APPENDIX E

PUBLIC INVOLVEMENT

**RE: DRAFT ENVIRONMENTAL ASSESSMENT
PROPOSED AMENDMENT TO UNITED AIRLINES OPERATIONS SPECIFICATION FOR TURBOJET
AIRCRAFT SERVICE TO MAMMOTH YOSEMITE AIRPORT, MAMMOTH LAKES, CA**

ATTACH ADDITIONAL DOCUMENTATION AS NECESSARY. INCLUDE SKETCH/PLAN.

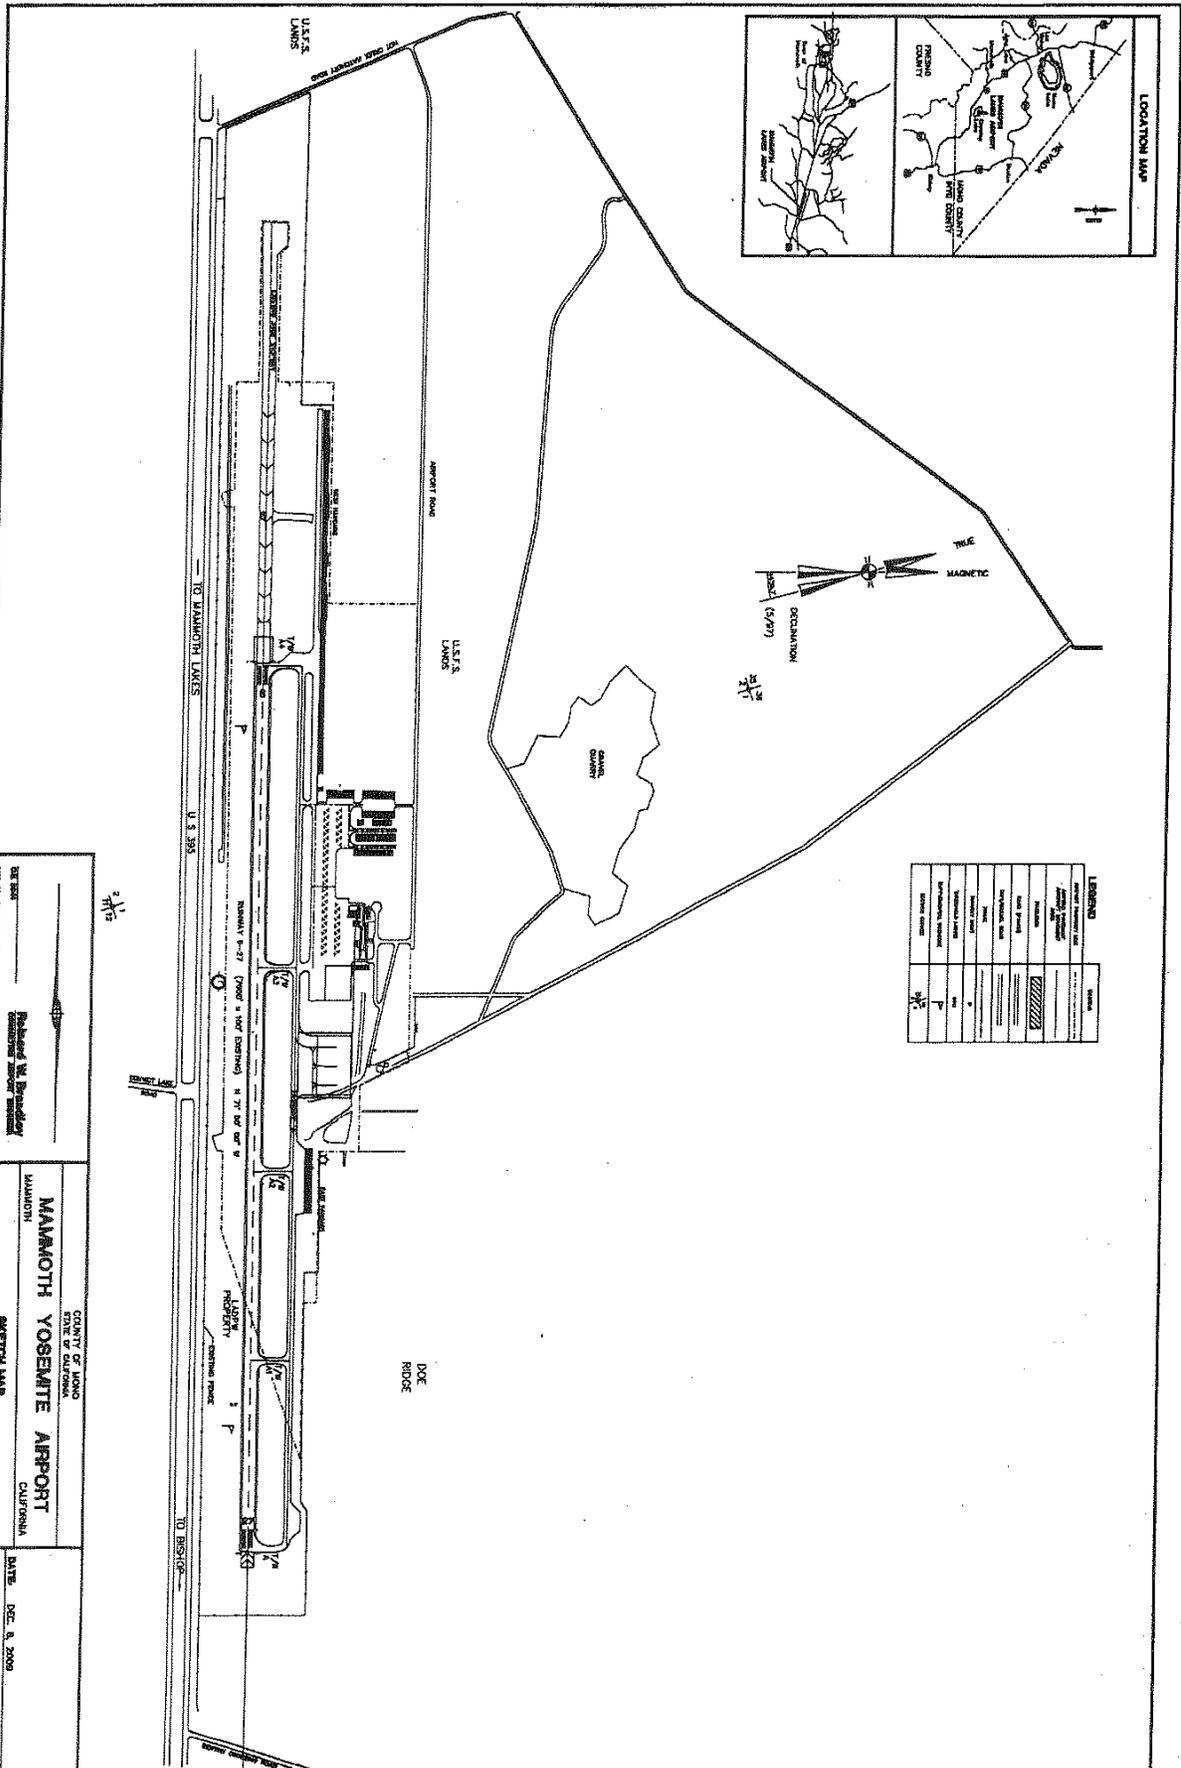
- 2) An Application for Modification of Standard from MMH to FAA, where the airport manager states that the Q-400 requires “an ARC C-III airport configuration.” (included herewith as Attachment 2);

**Comparison of ARC C-III Aircraft
Sonoma County Airport**

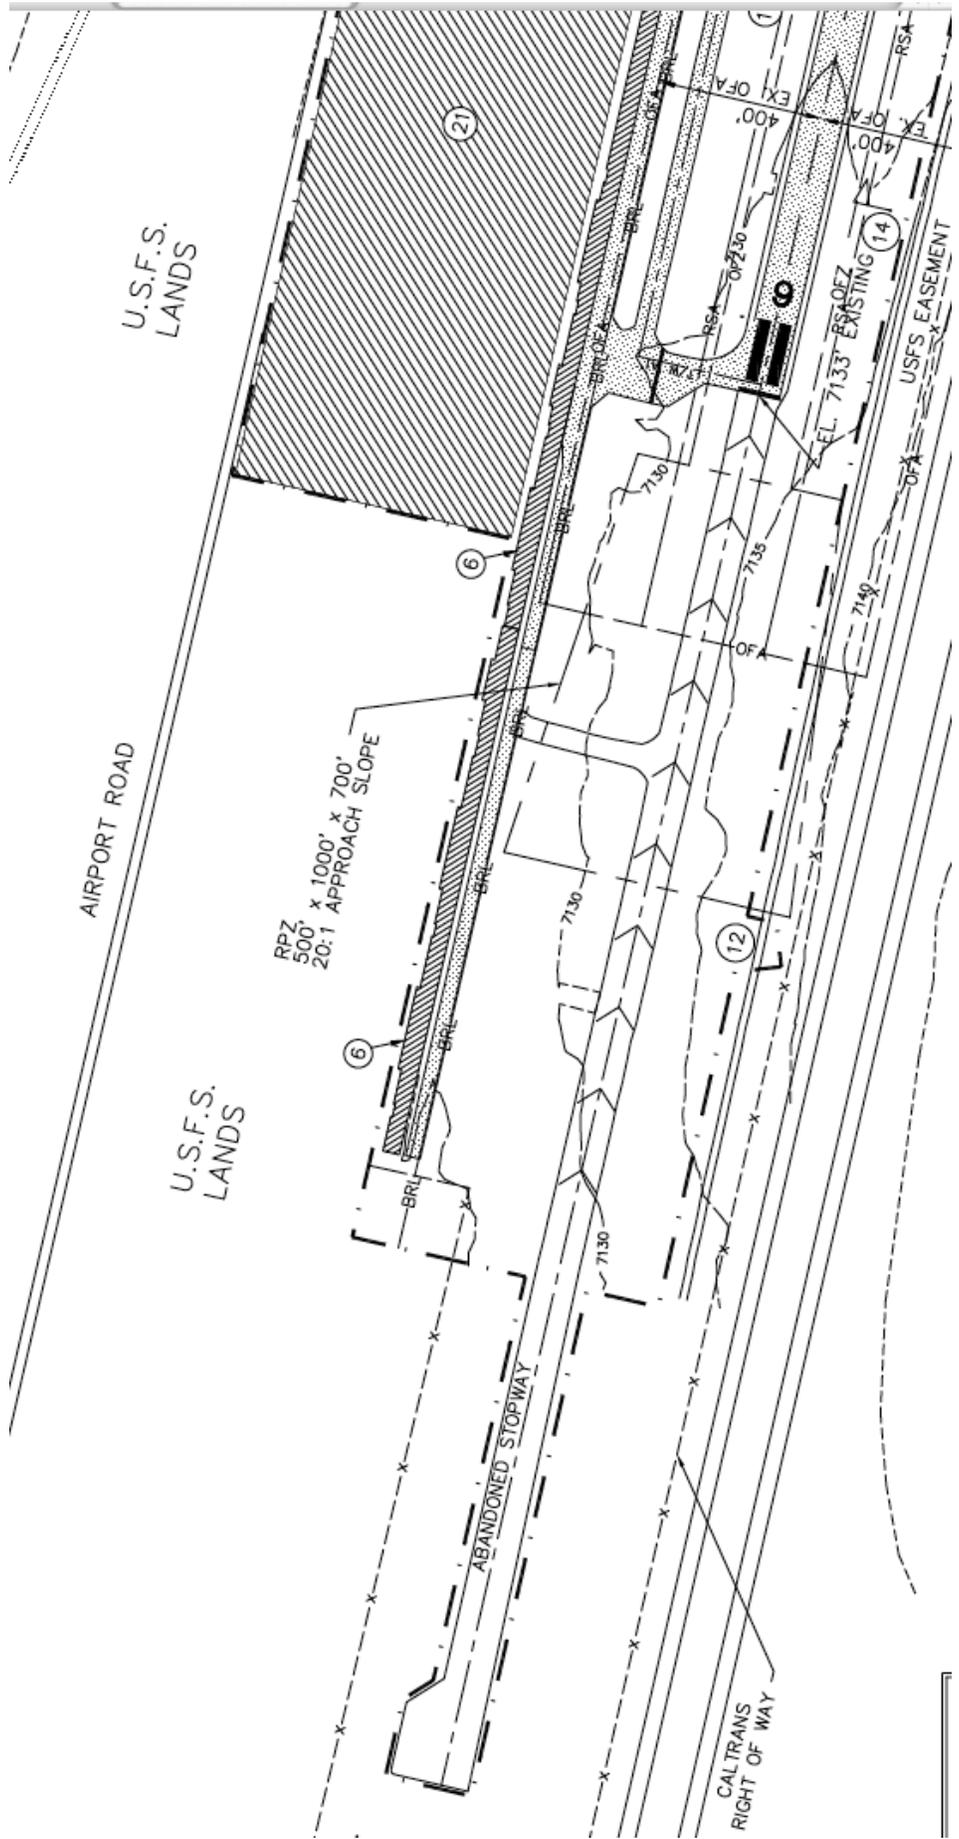
The box containing the figure 240' should read 300'.
